Three Mile Island Nuclear Station Unit 1 (TMI-1)
Operating License No. DPR-50
Docket No. 50-289
Auto Initiation of EFW

ENCLOSURE I

Figure 31
Seismic Test Setup
2AO-VAI ECEP 9236
Voltage-to-Current Converter

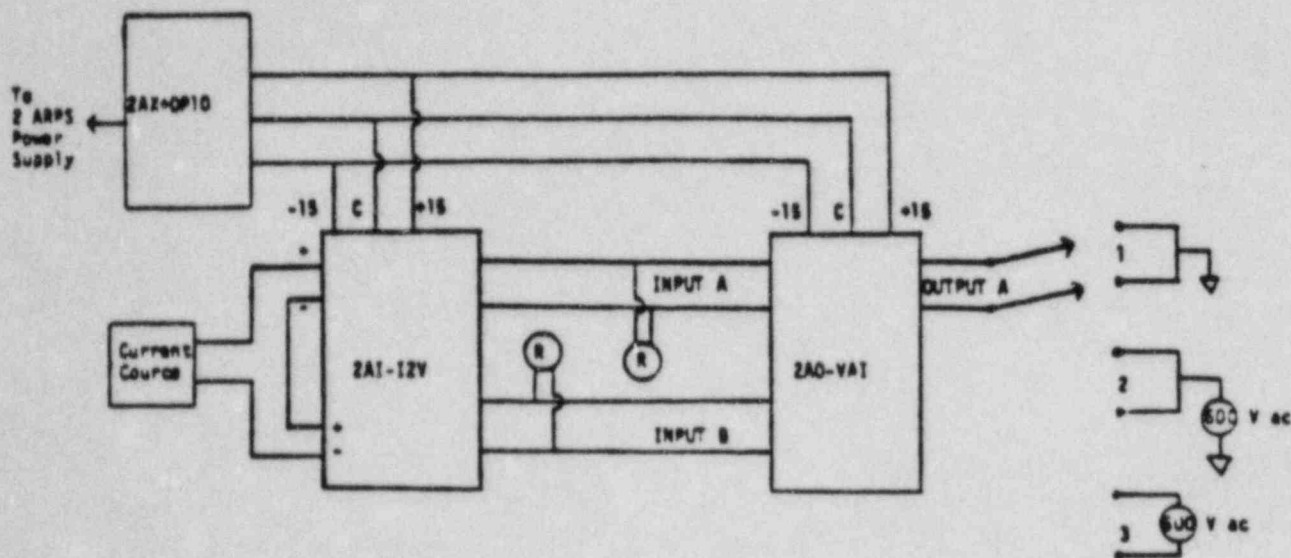
The licensee is to provide documentation identifying the Foxboro isolation devices. If they have not been previously reviewed by the NRC staff, sufficient documentation must be submitted to show that those components are qualified isolation devices. The documentation should include data to verify that the maximum credible fault (120 V AC, 20 amps) was applied to the output of the device in the transverse mode (between signal and return) and other faults were considered (i.e., open and short circuits).

Isolation devices N-2AO-VAI and N-2AO-L2C-R are used in the HSPS. Isolation device N-2AO-VAI qualification test report was supplied in our letter dated January 16, 1984 (5211-84-2300) and isolation device N-2AO-L2C qualification test report is available in the GPUN Corporate Office for review. The maximum credible fault (600 VAC/10 Sec/SSE) was applied to N-2AO-VAI (Attachment 1 QOAAA20-1 P72 Rev. 13) and N-2AO-L2C-R (Attachment 2 QOAAA20-1 P59 Rev. B).

Three tests are to be performed: 1) Ground both outputs of Channel A for 10 seconds during 1 SSE. 2) Apply 600 V ac between both output leads tied together and ground for 10 seconds during another SSE. 3) Apply 600 V ac across the output leads during a third SSE for 10 seconds; current source input at 12 mA, recorders calibrated for full scale traverse of 5 V dc $\pm 5\%$.
